RE: Bauer Builders Sports Center
UDC Final Approval Letter of Intent – 4845 Tradewinds Pkwy

BAUER BUILDERS SPORTS COMPLEX

4845 TRADEWINDS PARKWAY,
MADISON, WI

UDC FINAL APPROVAL

▪ **INITIAL SUBMISSION**

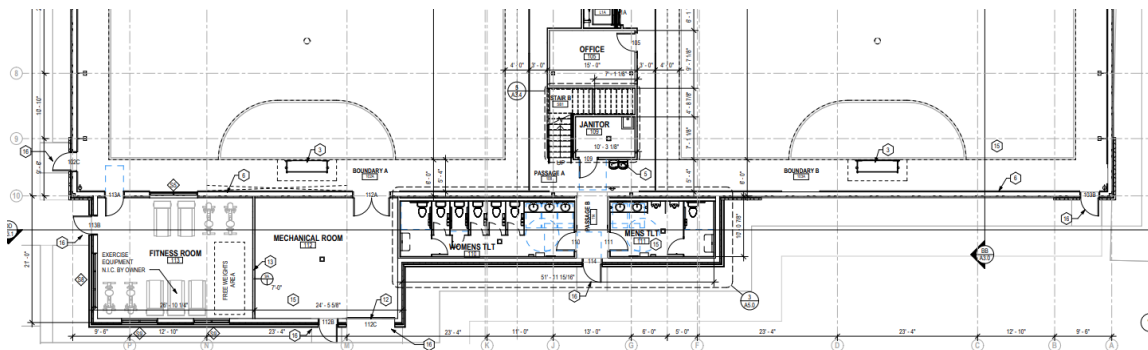
- *Plant groupings have been redesigned.*
- The single-story masses along the southside of the building be refined to be more integrated into the overall building design and footprint.

- *The mens' restroom has been relocated directly below the women's restroom, eliminating the offset/additional corner in the building footprint. This simplified the massing of the building creating one lower roof area at the rear of the facility. The masonry base continues around this portion of the building.*
